TfNSW reference: REN25/00108/002

Your reference: SSD-8911 (PAE-87001209)

SSD-8911, Sundown Solar Farm, Sturmans Road, Spring Mountain NSW 2360; Response to Response to Submissions (RTS)

Figure 1: Vehicle chassis outline beyond paved road area (indicated with red oval) at Newell Highway/Boothenda Road/Troy Bridge Road, Dubbo. Source: OSOM Assessment DRG EMM-020.

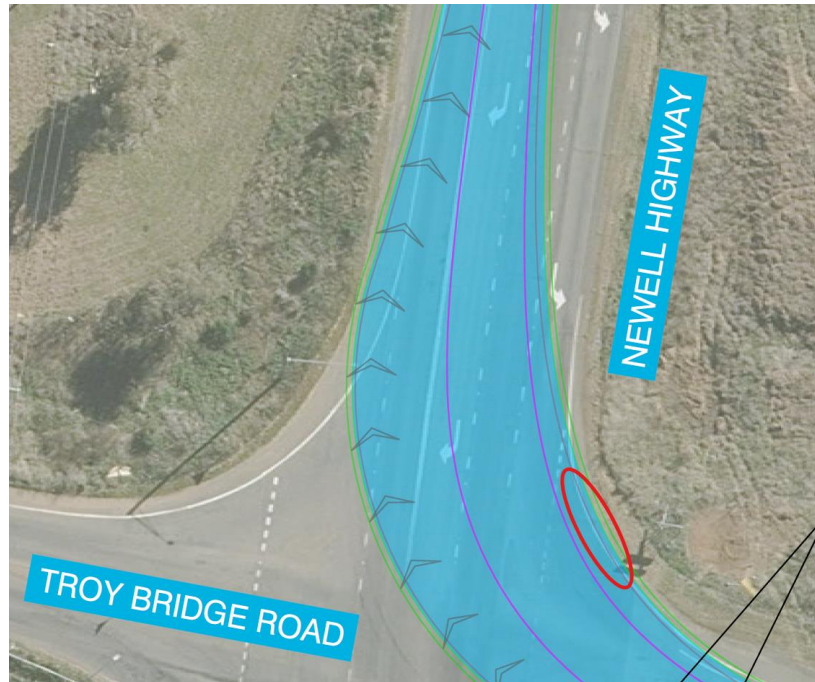
- d. There are multiple instances of swept paths showing the wheel path traversing outside of the paved road area, including, but not limited to, Newell Highway/Boothenda Road/Troy Bridge Road at Dubbo (Figure 1), and Putty Road/Mount Thorley Road/Jerrys Plains Road at Mount Thorley (Figure 2).

These examples are shown in Figures 1 and 2 of Attachment 2 of this response for ease of understanding. Note that these are some examples, and there may be more instances across the OSOM route. It is the proponent's responsibility to ensure that all vehicle movements are to be on sealed pavement.

Strategic concept designs are to be updated/provided with road and/or shoulder widening pavement design. See advisory notes for more information.
- e. Bettington Street/Vennacher Street, Merriwa, NSW
